Commission Agenda Report

Planning Commission Meeting
04-20-26
Item 5.C.

Subject: Coastal Development Permit No. 21-045 and Variance 26-003 – An application to grade and construct a new 594 square-foot, approximately 11 foot 2-inch tall, detached Accessory Dwelling Unit/Second Unit, including a variance for relief from Malibu Country Estates Overlay District standards associated with a proposed second building pad, reduced rear yard setback, wall heights, and allowances for impermeable coverage, structure height, and grading outside the existing building pad

Location: 24507 Vantage Point Terrace, partially within the appealable coastal zone
APN: 4458-033-006
Owner: Meissner Family Trust

Figure 2 – Applicant 1980 Aerial Image

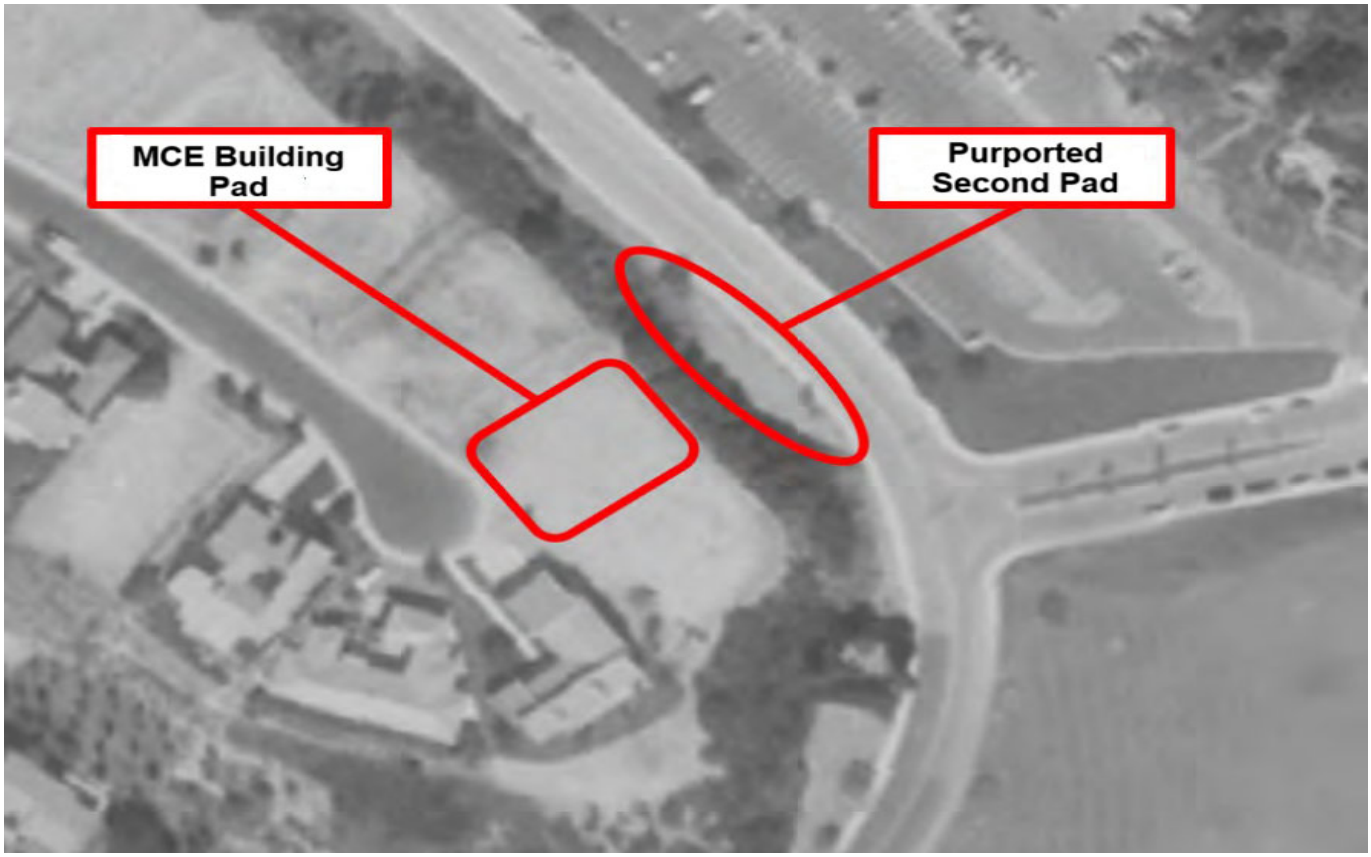
The rebuttal package included a historic aerial image from 1980 shown in Figure 2. The applicant representative asserted that the 1980 image proves there are two building pads on the subject parcel – one near Vantage Point Terrace and a second downslope near John Tyler Drive. Based on the Planning Division's review, the purported second building pad referenced on the 1980 image is not typical of graded building pads within the MCE Overlay and appeared to be typical vegetation clearing along a roadway and/or vehicle shoulder/turnout along the west side of John Tyler Drive. The same type of cleared area extends onto other MCE Overlay parcels along John Tyler Drive. Additional research

conducted by the Planning Division demonstrated that there is no evidence of a second building pad having been graded as part of the MCE Overlay development. This was confirmed in an aerial image obtained by the Planning Division dated 1976, as shown in Figure 3, dated four years prior to the 1980 image. The 1976 image more clearly depicts one building pad for the subject parcel adjacent to Vantage Point Terrance, similar to other parcels in the MCE Overlay. Even if there was a legally authorized second building pad, which the evidence does not suggest there is, the MCE Overlay district requires that development be limited to one building pad. This requirement is codified in both the LCP and MMC.

Figure 4 – Site Plan

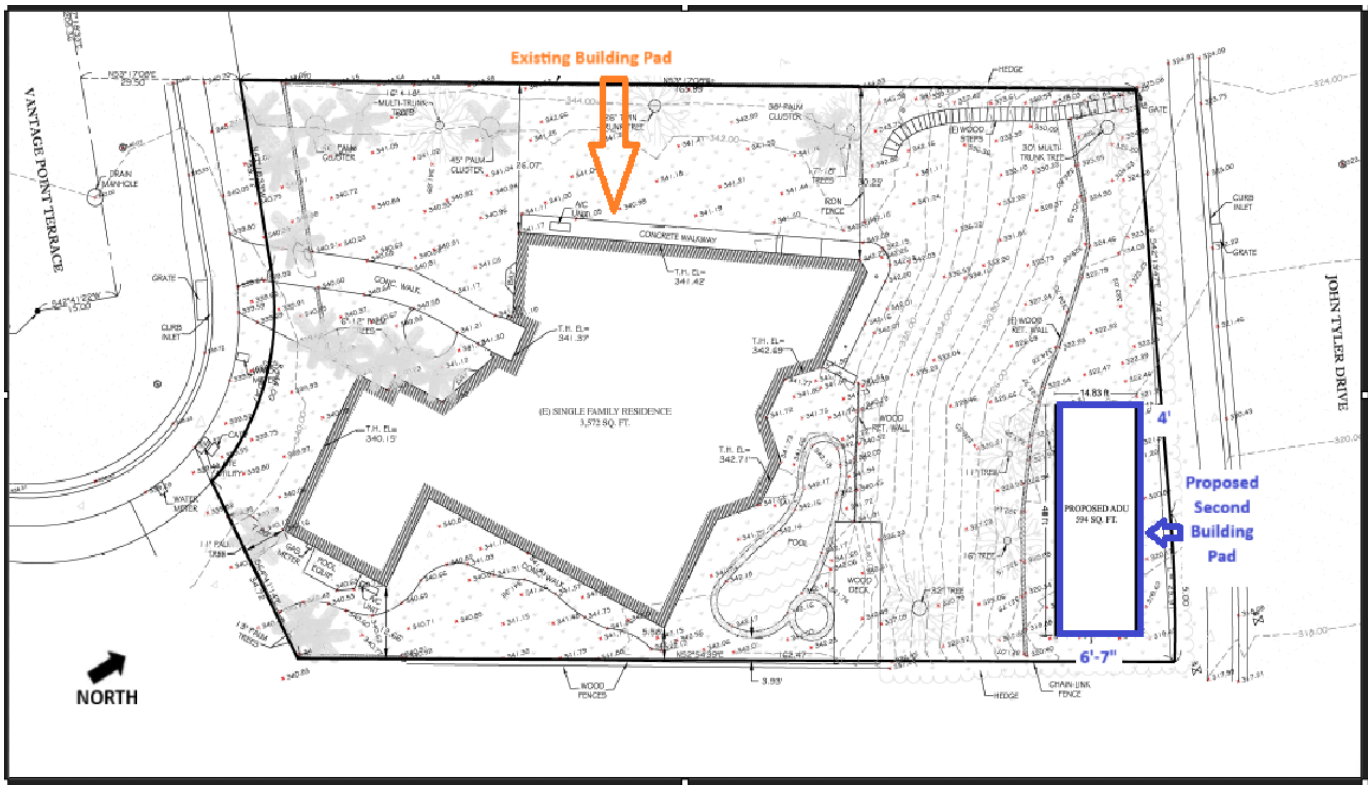
In Figure 4, the existing building pad is located at the top of the slope accessed from Vantage Point Terrace. The existing building pad includes a residence, garage, driveway, front and side yards, walkways, swimming pool, spa, and wooden deck. The proposed 14.83-foot by 40-foot prefabricated ADU/Second Unit is shown on the rear portion of the parcel downhill from the existing building pad. The ADU/Second Unit is proposed with a 4-foot rear yard setback and a 6-foot 7-inch interior yard setback.

Trees

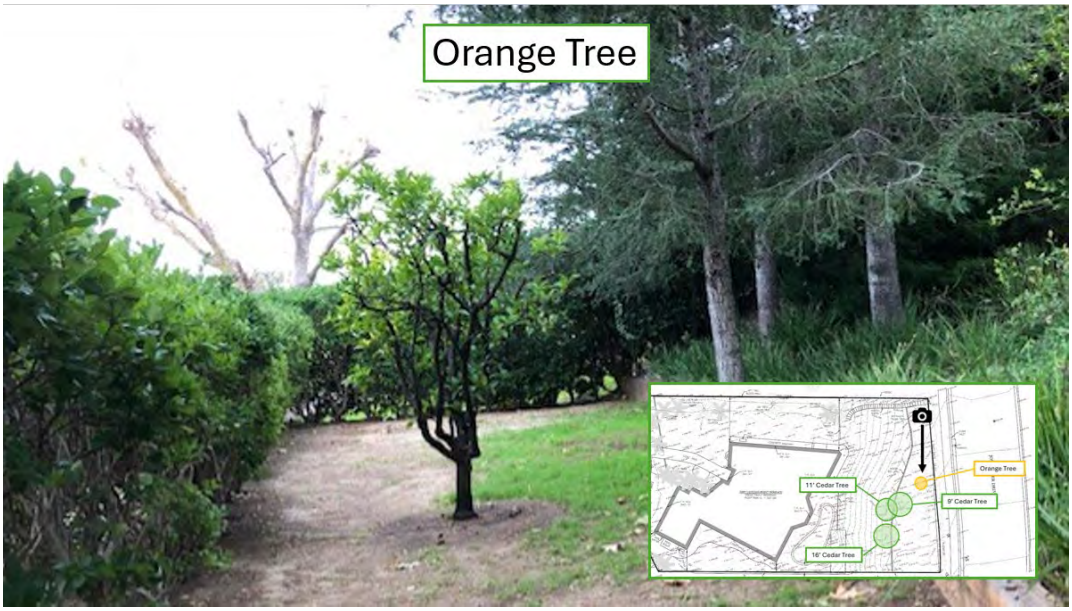
The Staff Report references four trees that were not explicitly identified on the site survey and allude to uncertainties about whether the project is in compliance with Native Tree protection policies of the LCP. To clarify, the identified trees consist of three cedar trees and one orange tree. These are non-native species and are not among the protected trees listed in LCP Chapter 5 (oak, walnut, sycamore, alder, and toyon).

1st Alternate Location: Over the pool, over the slope

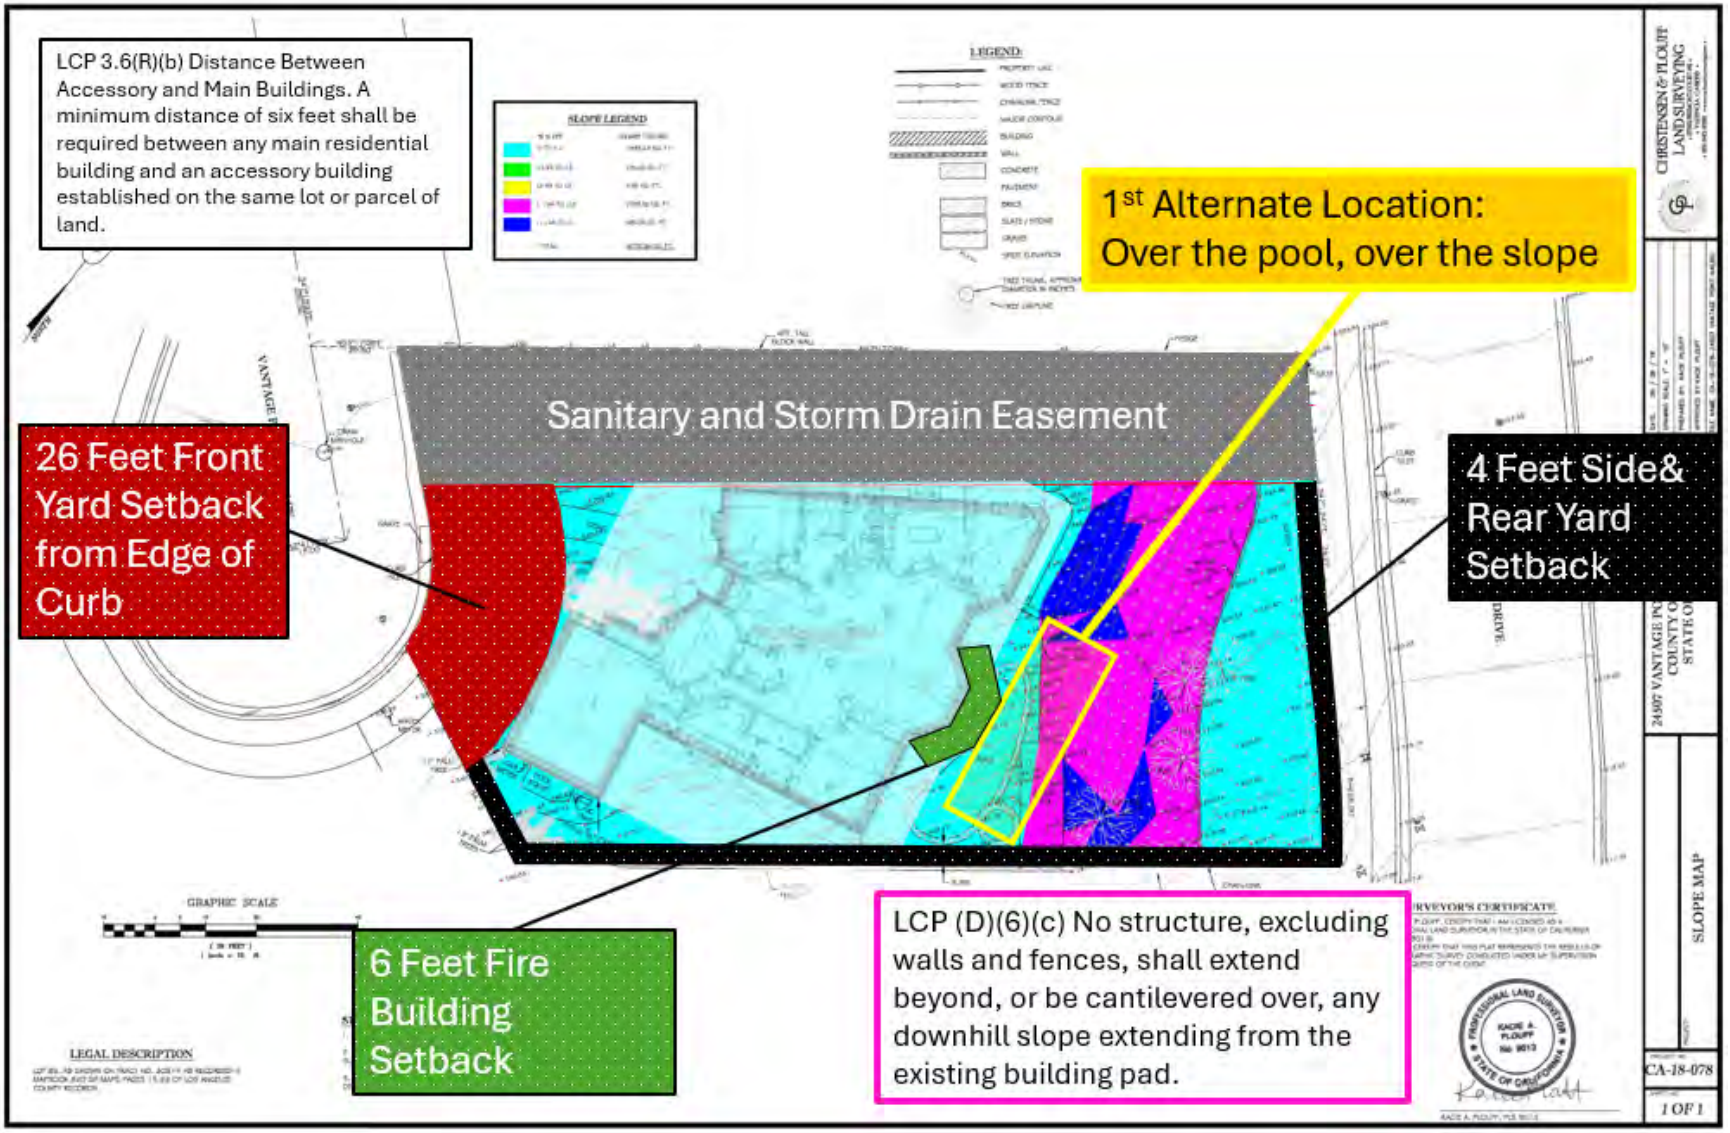
The rebuttal package also described two alternate locations for the ADU/Second Unit with justifications as to why each was considered by the applicant to be infeasible. Alternative 1 placed the ADU/Second Unit over the existing swimming pool and extension over the slope to the rear of the residence. The Planning Division concurred with the applicant that Alternative 1 is not feasible due to design constraints and additional development that would be required. Alternative 2 placed the ADU/Second Unit on the southeast side yard of the property near the southerly side of the residence and behind the three-car garage. The applicant states that location is not feasible because it does not accommodate a modular building. A modular building would be difficult to place in that location but a different type of ADU can be constructed in these alternate areas. Other alternatives not considered by the applicant, but appear feasible, include converting part of the existing structure and/or adding square footage to the residence within other available areas on the existing building pad. The Planning Division encouraged the applicant to select one of these alternatives so that the proposed ADU met all of the LCP required development standards, but that was declined by the applicant. An ADU is feasible on this subject site, and the staff is in support of a compliant ADU location, but the applicant wants to place the ADU in an area prohibited by the LCP and MMC.

Based on the Planning Division's review of the parcel, existing development, and thorough analysis of the variance justifications provided, it appears the applicant has design options adjacent to the existing residence on the side and/or front yards that could accommodate some form of an ADU/Second Unit and/or Junior ADU (JADU). As shown in Figure 6, potential locations are in the form of an attached structure to the residence and/or converted space associated with the residence or portion of the garage. An alternate design also appears feasible given that the existing building pad is sufficient in size to support other accessory uses including a swimming pool, spa, and wooden deck.

Staff asserts an *"alternate design also appears feasible given that the existing building pad is sufficient in size to support other existing uses including a pool, spa, and wooden deck."* However, the presence of recreational amenities does not demonstrate capacity for an ADU. The presence of a chimney or a bay window would not demonstrate the capacity for an ADU on a building pad any more than the presence of a pool. Capacity for one type of use is not inherently interchangeable with another. It is unclear whether Staff is proposing that the applicant remove the existing pool or deck in order to construct the ADU. However, that is not proposed, and it is not the applicant's desire to remove/trade existing development for the ADU, when the proposed development meets the requirements of State ADU law. Additionally, there are other considerations/constraints that make trading out the pool or deck for an ADU infeasible.

Even if the applicant were to remove the pool, the existing area would not support the proposed ADU. The alternatives analysis 1st Alternate Location clearly shows the infeasibility of this location for siting the ADU as it would extend over the slope beyond the building pad. Additionally, LCP Section 3.6(R)(b) requires *"A minimum distance of six feet…between any main residential building and an accessory building established on the same lot or parcel of land."* Finally, with or without the 6 ft. separation requirement, locating the ADU in the area of the pool/deck would block light/air to the living room, dining room, and primary (master) bedroom, significantly diminishing the use, enjoyment, and habitability of the existing residence.

Proposed ADU Siting – Lower Building Pad, 4-foot rear setbacks

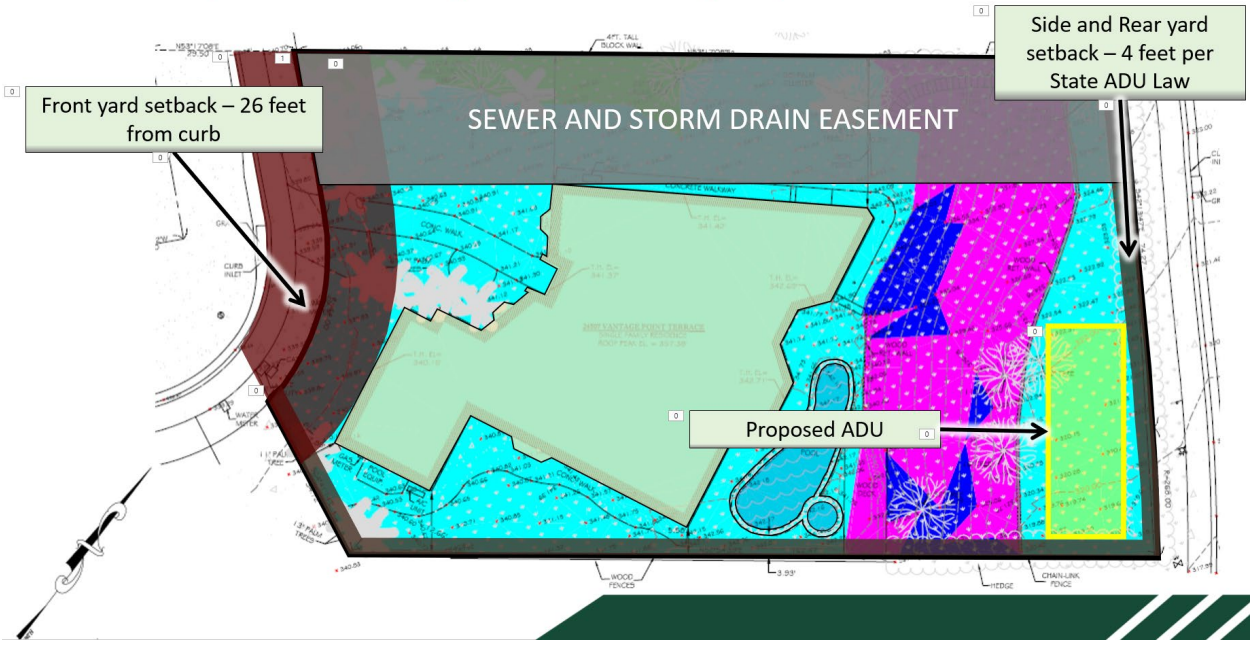
Figure 1 below shows the proposed ADU siting with variances for setback and second building pad, allowing siting fully on the lower building pad. Figure 2 shows the infeasibility of siting the ADU on the lower building pad without rear yard setback relief.
